ACCESSIBILITY ASSESSMENT

ADA TITLE II ASSESSMENT

Central Gardens
6804 Central Avenue
Pepper Mill Village, Maryland 20743

June 23, 2021

Map for Barrier ID: AX240312

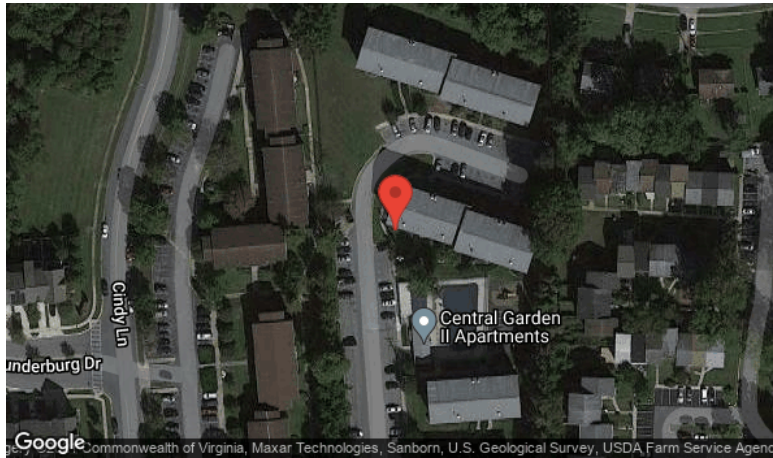
Assembly	Exterior Access Route
Type	Parking Space-Car
ADA Standard	502.4
Barrier Detail	The slope of the parking space is greater than 1:50 (2%).
Location Description	Accessible Parking Space P1-F
Observed	May 28, 2021 by Lloyd.fojas@bureauveritas.com
Site Conditions	The accessible parking space has a cross slope of 5.2%.

Remove and replace with a parking space that has no more than 1:50 (2%) slope in all directions. [EXCEPTION: Slopes not steeper than 1:48 (2.08%) shall be permitted.] Changes in level are not permitted. Parking spaces and access aisles shall be level with surface slopes not exceeding 1:50 in all directions. Parking spaces and access aisles serving them shall be compliant. Access aisles shall be at the same level as the parking spaces they serve. The quantity and order of magnitude cost estimate provided for this barrier are limited to the extent of the area identified as non-compliant. Additional costs that may be associated with removal of the barrier are not included. Re-stripe for a van accessible space at a location closest to an accessible facility entrance. For every six or fraction of six parking spaces required to comply, at least one shall be a van parking space. Van parking spaces shall be 132" wide minimum, shall be marked to define the width, and shall have a compliant adjacent access aisle. [EXCEPTION: Van parking spaces shall be permitted to be 96" wide minimum where the access aisle is 96" wide minimum.] Measurements shall be made to the centerline of the stripe. [EXCEPTION: Where accessible stalls and aisles are not adjacent to another stall or aisle, measurements shall be permitted to include the full width of the line defining the accessible parking space or aisle.] Parking spaces for vans, access aisles serving van spaces, and vehicular routes serving them shall provide a vertical clearance of 98" minimum.

Map for Barrier ID: AX239628

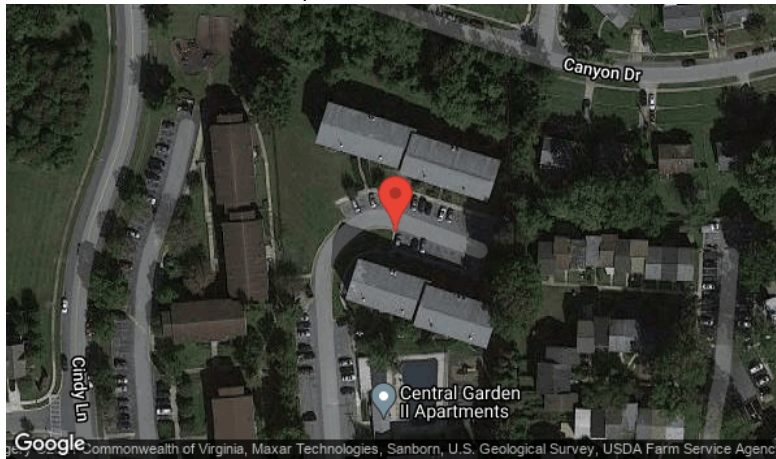
Assembly	Exterior Access Route
Type	Parking Space-Car
ADA Standard	502.4
Barrier Detail	The slope of the parking space is greater than 1:50 (2%).
Location Description	Accessible Parking Space P1-G and P1-H
Observed	May 28, 2021 by Lloyd.fojas@bureauveritas.com
Site Conditions	The accessible parking space has a cross slope of 4.2%.

Remove and replace with a parking space that has no more than 1:50 (2%) slope in all directions. [EXCEPTION: Slopes not steeper than 1:48 (2.08%) shall be permitted.] Changes in level are not permitted. Parking spaces and access aisles shall be level with surface slopes not exceeding 1:50 in all directions. Parking spaces and access aisles serving them shall be compliant. Access aisles shall be at the same level as the parking spaces they serve. The quantity and order of magnitude cost estimate provided for this barrier are limited to the extent of the area identified as non-compliant. Additional costs that may be associated with removal of the barrier are not included. Re-stripe for a car accessible space at a location closest to an accessible facility entrance. Car parking spaces shall be 96" wide minimum, shall be marked to define the width, and shall have a compliant adjacent access aisle. Measurements shall be made to the centerline of the stripe. [EXCEPTION: Where accessible stalls and aisles are not adjacent to another stall or aisle, measurements shall be permitted to include the full width of the line defining the accessible parking space or aisle.] Parking spaces for cats, access aisles serving parking spaces, and vehicular routes serving them shall provide a vertical clearance of 98" minimum.

Map for Barrier ID: AX239569

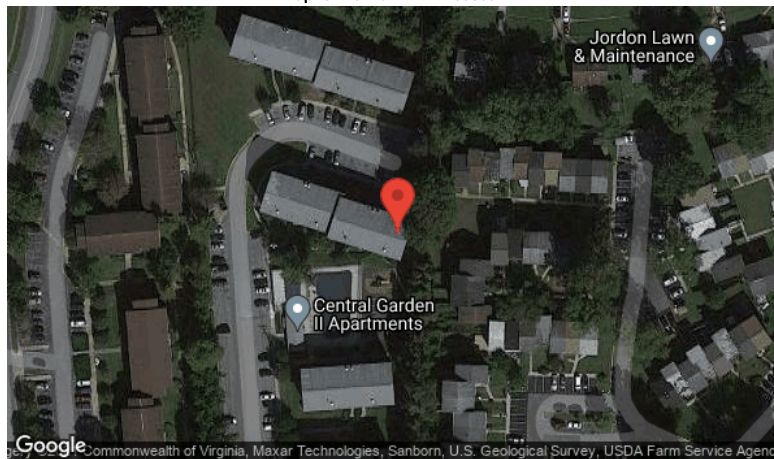
Assembly	Exterior Access Route
Type	Parking Space-Van
ADA Standard	502.4
Barrier Detail	The parking space slope is greater than 1:50 (2%).
Location Description	Accessible Parking Space P1-I
Observed	May 28, 2021 by Lloyd.fojas@bureauveritas.com
Site Conditions	The accessible parking space has a cross slope of 5.5%.

Remove and replace with a van space which has a slope of maximum 1:50 (2%) in all directions. [EXCEPTION: Slopes not steeper than 1:48 (2.08%) shall be permitted.] Changes in level are not permitted. Parking spaces and access aisles serving them shall be compliant. Width measurements shall be made from the centerline of the markings. [EXCEPTION: Where parking spaces or access aisles are not adjacent to another parking space or access aisle, measurements shall be permitted to include the full width of the line defining the parking space or access aisle.] The quantity and order of magnitude cost estimate provided for this barrier are limited to the extent of the area identified as non-compliant. Additional costs that may be associated with removal of the barrier are not included.

Map for Barrier ID: AX240323

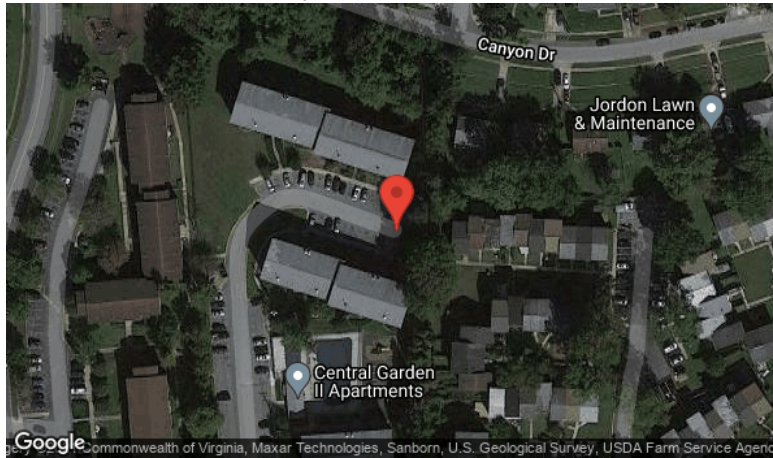
Provide the required minimum number of accessible parking spaces per table 4.1.1. In addition, where parking stalls are assigned to individual dwelling units, at least one accessible space should be provided for each mobility accessible dwelling unit. Where parking is provided for all residents, one accessible parking space shall be provided for each accessible dwelling unit; and where parking is provided for only a portion of the residents, an accessible parking space shall be provided on request of the occupant of an accessible dwelling unit. Parking spaces for disabled people shall be at least 96" wide and shall have an adjacent access aisle 60" wide minimum (see Fig. 9). [EXCEPTION: If accessible parking spaces for vans are provided, each should have an adjacent access aisle at least 96" wide.] Parking access aisles shall be part of an accessible route to the building or facility entrance. Two accessible parking spaces may share a common access aisle. Parked vehicle overhangs shall not reduce the clear width of an accessible circulation route. Parking spaces and access aisles shall be level with surface slopes not exceeding 1:50 (2%) in all directions. Accessible parking spaces shall be designated as reserved for the disabled by a sign showing the International Symbol of Accessibility. Such signs shall not be obscured by a vehicle parked in the space. This barrier applies only to non-public parking in residential developments. Other applicable federal, state and local regulations may supercede this barrier, and have stricter requirements. The quantity and order of magnitude cost estimate provided for this barrier are limited to the extent of the area identified as non-compliant. Additional costs that may be associated with removal of the barrier are not included.

Map for Barrier ID: AX240244

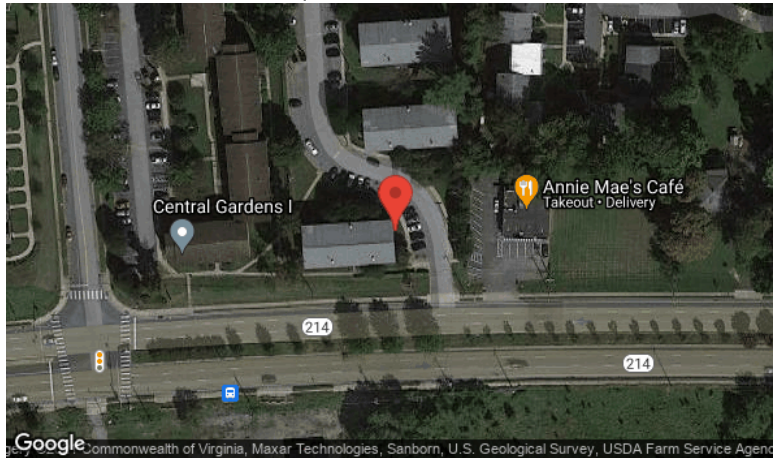
Assembly	Exterior Access Route
Type	Curb Ramp
ADA Standard	406.2
Barrier Detail	A curb ramp is not provided where the accessible route crosses a curb.
Location Description	Curb Ramp CR-1 and CR-2
Observed	May 28, 2021 by Lloyd.fojas@bureauveritas.com
Site Conditions	Curb ramps are not provided where the accessible route crosses the curbs.

Install a compliant curb ramp. Compliant curb ramps shall be provided wherever an accessible route crosses a curb. Curb ramp runs shall have a running slope not steeper than 1:12. Cross slope of ramp runs shall not be steeper than 1:48. The running slope in new construction shall be 1:12 maximum. [EXCEPTION: In existing sites, buildings, and facilities built before 1/26/92, ramps shall be permitted to have running slopes steeper than 1:12 where such slopes are necessary due to space limitations. The running slope can be 1:10 to 1:8 (10% to 12.5%) for a maximum rise of 3" OR 1:10 to 1:12 (8.3% to 10%) for a maximum rise of 6".] Where provided, flare slopes shall be maximum 1:10 (10%). Provide a landing at the top of the curb ramp. The landing clear length shall be 36" minimum. The landing clear width shall be minimum 48" wide, and at least as wide as the curb ramp, excluding flared sides. Changes in level are not permitted. Slopes not steeper than 1:48 shall be permitted.

Map for Barrier ID: AX239620

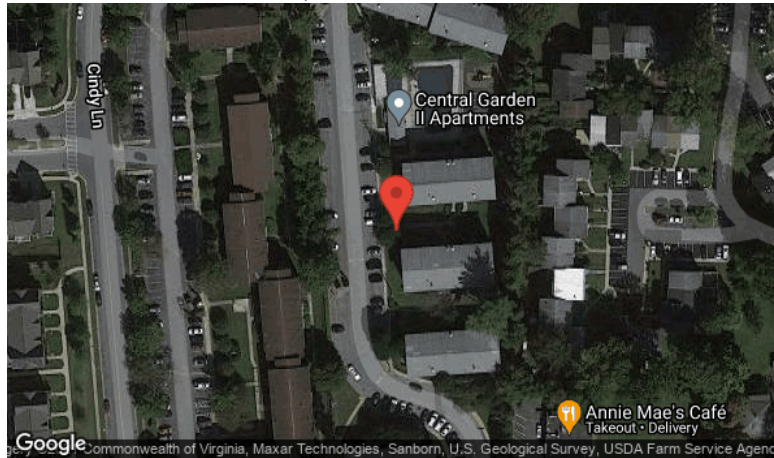
Assembly	Exterior Access Route
Type	Curb Ramp
ADA Standard	304, 406
Barrier Detail	A compliant parallel curb ramp is not provided.
Location Description	Curb Ramp CR-3
Observed	May 28, 2021 by Lloyd.fojas@bureauveritas.com

Replace the standard curb ramp with a parallel curb ramp. The bottom landing clear width at the bottom of the curb ramp runs shall be 60" minimum to allow for a 90 degree turn. The top landings shall be minimum 36" deep in the direction of travel. The slope of the landings, where the landing connects to a sidewalk aligned perpendicular or angled to the curb ramp run requiring a wheelchair turn, shall be maximum 1:48 (2.08%). The slope of the landing shall be maximum 1:48 (2.08%). The curb ramp should be removed and replaced with a compliant ramp with no greater than the maximum allowable slopes of a ramp. Ramp runs shall have a running slope not steeper than 1:12 (8.33%). Cross slope of ramp runs shall not be steeper than 1:48. The running slope in new construction shall be 1:12 (8.33%) maximum. [EXCEPTION: In existing sites, buildings, and facilities built before 1/26/92, ramps shall be permitted to have running slopes steeper than 1:12 where such slopes are necessary due to space limitations. In facilities built before 1/26/92, the running slope can be 1:10 to 1:8 (10% to 12.5%) for a maximum rise of 3" OR 1:10 to 1:12 (8.3% to 10%) for a maximum rise of 6".]

Map for Barrier ID: AX239629

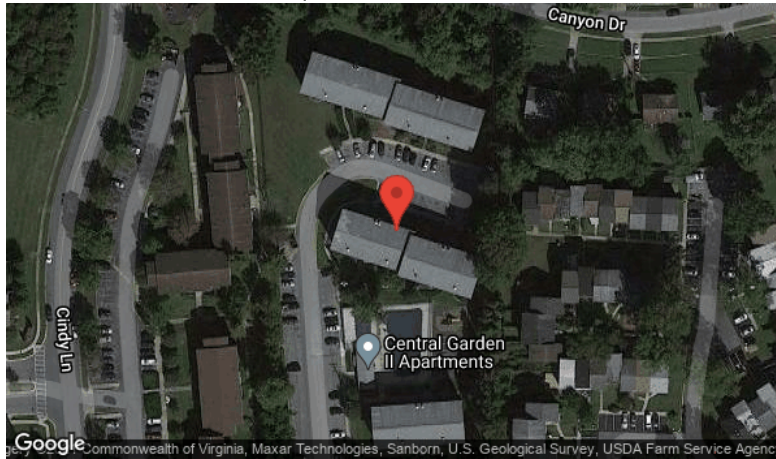
Assembly	Exterior Access Route
Type	Curb Ramp
ADA Standard	405.2; Table 405.2; 406; 406.2
Barrier Detail	The curb ramp does not meet the slope requirements.
Location Description	Curb Ramp CR-5
Observed	May 28, 2021 by Lloyd.fojas@bureauveritas.com

The curb ramp should be removed and replaced with a compliant curb ramp with no greater than the maximum allowable slopes of a ramp. Curb ramp runs shall have a running slope not steeper than 1:12 (8.33%). Cross slope of curb ramp runs shall not be steeper than 1:48. The running slope in new construction shall be 1:12 (8.33%) maximum. [EXCEPTION: In existing sites, buildings, and facilities built before 1/26/92, ramps and curb ramps shall be permitted to have running slopes steeper than 1:12 where such slopes are necessary due to space limitations. In facilities built before 1/26/92, the running slope can be 1:10 to 1:8 (10% to 12.5%) for a maximum rise of 3" OR 1:10 to 1:12 (8.3% to 10%) for a maximum rise of 6".] Where flares are provided, flare slopes shall not be greater than 1:10 (10%). [EXCEPTION: In alterations, where there is no landing at the top of curb ramps, curb ramp flares shall be provided and shall not be steeper than 1:12.]

Map for Barrier ID: AX240243

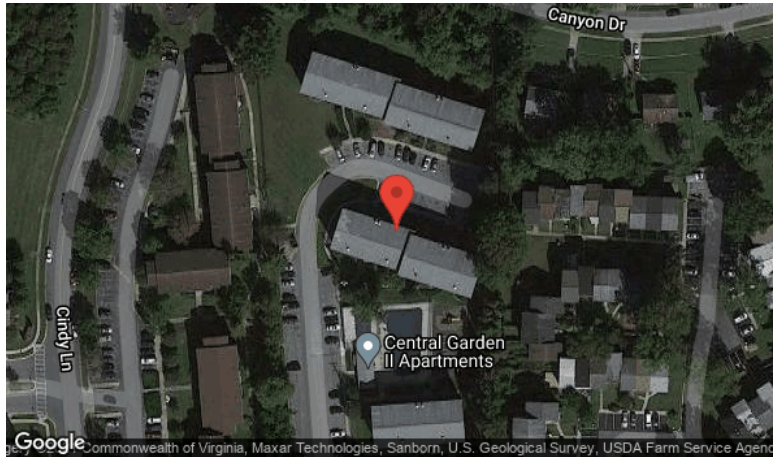
Barrier Detail

Provide a level landing at the top of the curb ramp with maximum slope 1:48 (2.08%). The landing clear length shall be 36" minimum. The landing clear width shall be at least as wide as the curb ramp, excluding flared sides. Changes in level are not permitted. Slopes not steeper than 1:48 shall be permitted. [EXCEPTION: In alterations, where there is no landing at the top of curb ramps, curb ramp flares shall be provided and shall not be steeper than 1:12.] The landing slope may have maximum 1:20 (5%) running slope, if the sidewalk is parallel/continuous with the running slope of the curb ramp, and a sidewalk with the dominant path of travel perpendicular to the dominant path of travel of the curb ramp is not provided.

Map for Barrier ID: AX240311

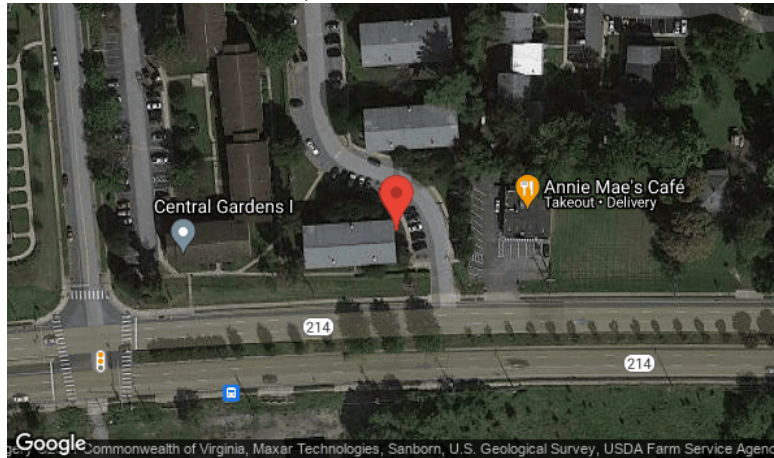
Assembly	Exterior Access Route
Type	Curb Ramp
ADA Standard	406.2
Barrier Detail	A curb ramp is not provided where the accessible route crosses a curb.
Location Description	Curb Ramp CR-6
Observed	May 28, 2021 by Lloyd.fojas@bureauveritas.com
Site Conditions	A curb ramp is not provided where the accessible route crosses the curb.

Install a compliant curb ramp. Compliant curb ramps shall be provided wherever an accessible route crosses a curb. Curb ramp runs shall have a running slope not steeper than 1:12. Cross slope of ramp runs shall not be steeper than 1:48. The running slope in new construction shall be 1:12 maximum. [EXCEPTION: In existing sites, buildings, and facilities built before 1/26/92, ramps shall be permitted to have running slopes steeper than 1:12 where such slopes are necessary due to space limitations. The running slope can be 1:10 to 1:8 (10% to 12.5%) for a maximum rise of 3" OR 1:10 to 1:12 (8.3% to 10%) for a maximum rise of 6".] Where provided, flare slopes shall be maximum 1:10 (10%). Provide a landing at the top of the curb ramp. The landing clear length shall be 36" minimum. The landing clear width shall be minimum 48" wide, and at least as wide as the curb ramp, excluding flared sides. Changes in level are not permitted. Slopes not steeper than 1:48 shall be permitted.

Map for Barrier ID: AX239624

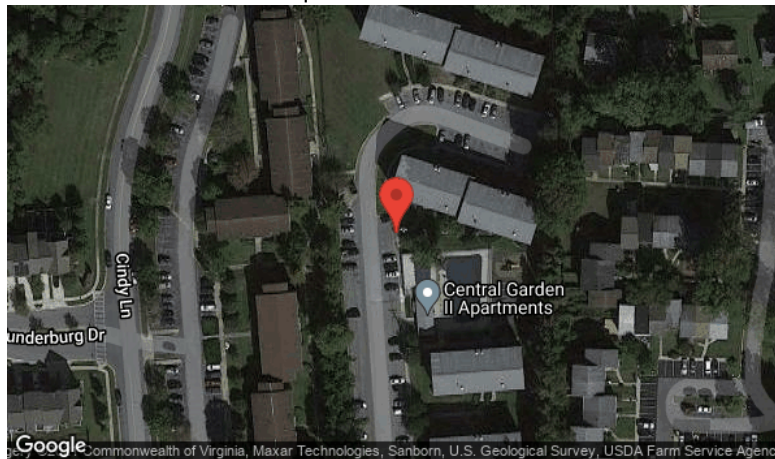
Assembly	Exterior Access Route
Type	Exterior Accessible Route
ADA Standard	403.3
Barrier Detail	The accessible route has running slopes greater than 1:20 (5%).
Location Description	From Accessible Parking to Buildings 6810 and 6812 Entrances
Observed	May 28, 2021 by Lloyd.fojas@bureauveritas.com
Site Conditions	The accessible route has running slopes up to 9.4%.

Grade the accessible route to maximum 1:20 (5%) running slope. An accessible route has maximum 1:20 (5%) running slope, maximum 1:50 (2%) cross slope, and minimum clear width 36". [EXCEPTION: Cross slopes not greater than 1:48 (2.08%) are permitted.] Where grading to maximum running slope of 1:20 (5% running slope) is not possible, provide a compliant ramped surface within the walkway with maximum slope 1:12 (8.33%) and maximum ramp run rise of 6" without handrails. If a ramped surface with running slopes greater than 1:20 (5%) and maximum 1:12 (8.33%) rises more than 6", handrails are required. A compliant ramp has maximum 1:12 (8.33%) running slope, maximum ramp run rise 30", landings at the top and bottom of ramp runs, handrails where the ramp run rise is greater than 6", and edge protection with exceptions. The cost estimate for this barrier removal is based on grading the running slope to maximum 1:20 (5%). The quantity and order of magnitude cost estimate provided for this barrier are limited to the extent of the area identified as non-compliant. Additional costs that may be associated with removal of the barrier are not included.

Map for Barrier ID: AX239560

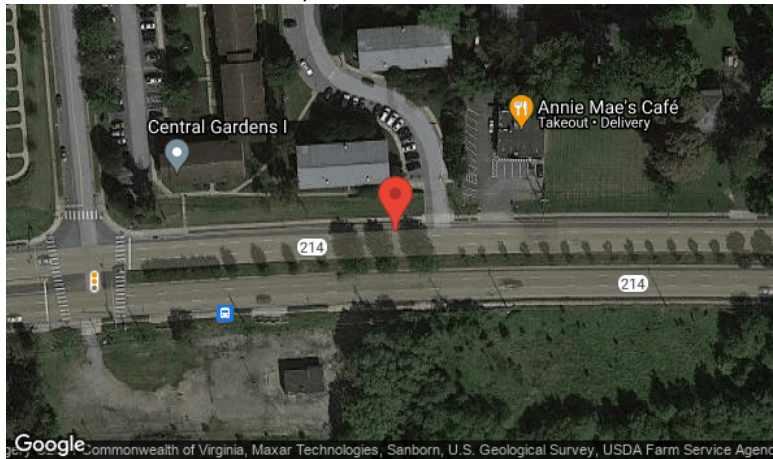
Barrier Detail

Provide an accessible route from accessible parking spaces, passenger loading zones, public streets, public sidewalks, and public transportation stops. At least one accessible route shall be provided within the site from accessible parking spaces and accessible passenger loading zones; public streets and sidewalks; and public transportation stops to the accessible building or facility entrance they serve. An accessible route has maximum 1:20 (5%) running slope and maximum 1:50 (2%) cross slope. [EXCEPTION: Cross slopes not greater than 1:48 (2.08%) are permitted.] The clear width of walking surfaces shall be 36" minimum. [EXCEPTION: The clear width shall be permitted to be reduced to 32" minimum for a length of 24" maximum provided that reduced width segments are separated by segments that are 48" long minimum and 36" wide minimum.] Where grading to maximum running slope of 1:20 (5% running slope) is not possible, provide a compliant ramped surface within the walkway with maximum slope 1:12 (8.33%) and maximum ramp run rise of 6" without handrails. If a ramped surface with running slopes greater than 1:20 (5%) and maximum 1:12 (8.33%) rises more than 6", handrails are required. A compliant ramp has maximum 1:12 (8.3%) running slope, maximum ramp run rise 30", landings at the top and bottom of ramp runs, handrails where the ramp run rise is greater than 6", and edge protection with exceptions. The cost estimate for this barrier removal is based on grading the running slope to maximum 1:20 (5%). The quantity and order of magnitude cost estimate provided for this barrier are limited to the extent of the area identified as non-compliant. Additional costs that may be associated with removal of the barrier are not included.

Map for Barrier ID: AX240216

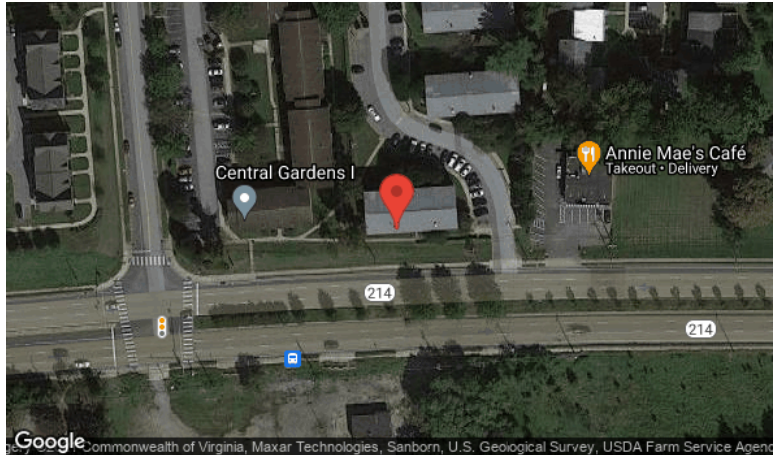
Assembly	Exterior Access Route
Type	Ramp
ADA Standard	405, 505
Barrier Detail	The ramp is required but not provided.
Location Description	From Parking to Building 6800
Observed	May 28, 2021 by Lloyd.fojas@bureauveritas.com

Provide a compliant ramp or reduce the walking surface to maximum 1:20 (5%) running slope. The cost estimate for this barrier removal is based on providing a ramp, rather than grading the running slope to maximum 1:20 (5%). Ramp runs shall have a running slope not steeper than 1:12, and a cross slope not steeper than 1:48. [EXCEPTION: In existing sites built pre-1/26/92, buildings, and facilities, ramps shall be permitted to have running slopes steeper than 1:12 where such slopes are necessary due to space limitations. Where slopes are steeper than 1:10 but not steeper than 1:8, the rise shall be 3" maximum. Where slopes are steeper than 1:12 but not steeper than 1:10, the rise shall be 6" maximum.] The clear width of a ramp run and, where handrails are provided, the clear width between handrails shall be 36" minimum. The clear width of a ramp run and, where handrails are provided, the clear width between handrails shall be 36" minimum. [EXCEPTION: Within employee work areas, the required clear width of ramps that are a part of common use circulation paths shall be permitted to be decreased by work area equipment provided that the decrease is essential to the function of the work being performed.] Ramp runs shall have maximum 30" rise. Ramp landings shall be located at the top and bottom of ramp runs, and at turns of ramp direction. Landings shall be 1:48 maximum slope in any direction. Landings shall be minimum 60" length, and as wide as the ramp run, except ramp landings at turns which shall be minimum 60" x 60" minimum. All ramp runs with a rise of 6" or greater shall have handrails on each side of the ramp. Handrails shall be compliant. The top of the handrail gripping surface shall be 34" minimum to 38" maximum vertically above the ramp surface. Provide edge protection on the sides of each ramp run which rises more than 6" and on ramp landings. Compliant edge protection shall be provided on each side of ramp runs and at each side of ramp landings. Compliant edge protection is EITHER a curb or barrier that prevents the passage of a 4" diameter sphere where the sphere is within 4" of the ramp surface OR an extension of the ramp surface 12" minimum beyond the inner face of the rail. [EXCEPTIONS: 1. Edge protection shall not be required on ramps that are not required to have handrails and have sides. 2. Edge protection shall not be required on the sides of ramp landings serving an adjoining ramp run or stairway. 3. Edge protection shall not be required on the sides of ramp landings having a vertical drop-off of 1/2" maximum within 10" horizontally of the minimum required landing area.] Ramps and their approaches shall be designed so that water will not accumulate on walking surfaces.

Map for Barrier ID: AX240218

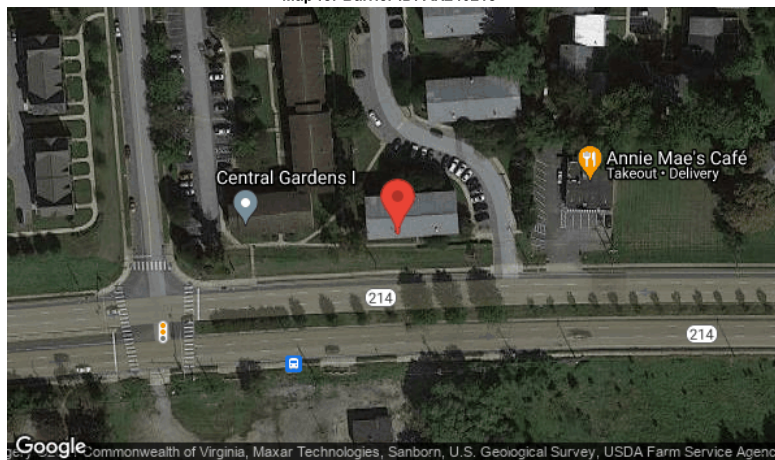
Assembly	Exterior Access Route
Type	Ramp
ADA Standard	405.8 and 505
Barrier Detail	The ramp run has a rise greater than 6"; however, handrails are not provided.
Location Description	From Parking to Building 6800
Observed	May 28, 2021 by Lloyd.fojas@bureauveritas.com

Provide compliant handrails or provide ramp runs with maximum 6" rise. Handrails are required on ramp runs which rise more than 6". Replace with continuous handrails at a consistent height above the ramp on both sides of the ramp. Inside handrails on switchback or dogleg stairs and ramps shall be continuous between runs. Top of gripping surfaces of handrails shall be 34" minimum and 38" maximum vertically above ramp surfaces. Handrails shall be at a consistent height above ramp surfaces. Clearance between handrail gripping surfaces and adjacent surfaces shall be 1-1/2" minimum. Handrail gripping surfaces shall be continuous along their length and shall not be obstructed along their tops or sides. The bottoms of handrail gripping surfaces shall not be obstructed for more than 20% of their length. Where provided, horizontal projections shall occur 1-1/2" minimum below the bottom of the handrail gripping surface. [EXCEPTIONS: 1. Where handrails are provided along walking surfaces with slopes not steeper than 1:20, the bottoms of handrail gripping surfaces shall be permitted to be obstructed along their entire length where they are integral to crash rails or bumper guards. 2. The distance between horizontal projections and the bottom of the gripping surface shall be permitted to be reduced by 1/8" for each 1/2" of additional handrail perimeter dimension that exceeds 4".] Handrail gripping surfaces with a circular cross section shall have an outside diameter of 1-1/4" minimum and 2" maximum. Handrail gripping surfaces with a non-circular cross section shall have a perimeter dimension of 4" minimum and 6-1/4" maximum, and a cross-section dimension of 2-1/4" maximum. Handrail gripping surfaces and any surfaces adjacent to them shall be free of sharp or abrasive elements and shall have rounded edges. Handrails shall not rotate within their fittings. Handrail gripping surfaces shall extend beyond and in the same direction of ramp runs. [EXCEPTIONS: 1. Extensions shall not be required for continuous handrails at the inside turn of switchback or dogleg ramps AND 3. In alterations, full extensions of handrails shall not be required where such extensions would be hazardous due to plan configuration.] Ramp handrails shall extend horizontally above the landing for 12" minimum beyond the top and bottom of ramp runs. Extensions shall return to a wall, guard, or the landing surface, or shall be continuous to the handrail of an adjacent ramp run.
